MASHIYAT APPAREL LTD

12 August 2025

2. Observations

Observation 01: Lack of load plan & management system - Admin Building

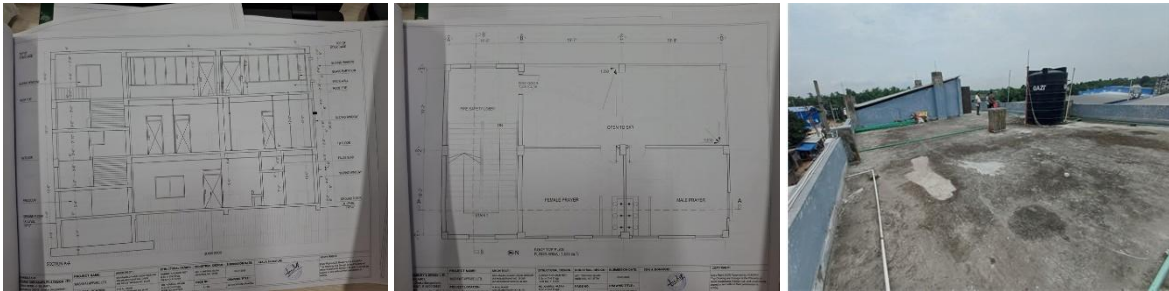
Description: Floor load plan not found posted on suspended floors. Prepare and post the floor load plan on each suspended floor and maintain accordingly.

Item No	Observation	Action Plan	Timeline
1.	Lack of load plan & management system – Admin Building	Prepare load plan along with design report & submit it to RSC. Post floor load plan on each floor, mark storage area & height (if any) & maintain floor loading accordingly.	within 6 weeks

Observation 05: Potential falling hazard due to low height parapet - Admin Building

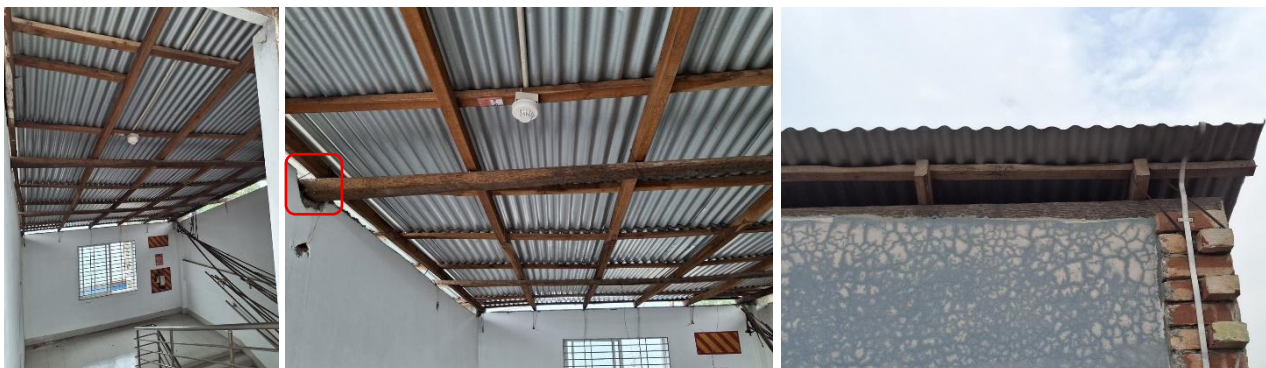
Description: Parapet wall height was found less than 750mm (30 inches) on the roof. Increase the parapet wall height.

4.	Exposed rebar in stair landing – Admin Building	Provide anti-rusting coating on exposed rebar.	within 6 weeks
5.	Potential falling hazard due to low height parapet - Admin Building	Increase the roof parapet wall height as per BNBC-2020 requirements.	within 6 weeks
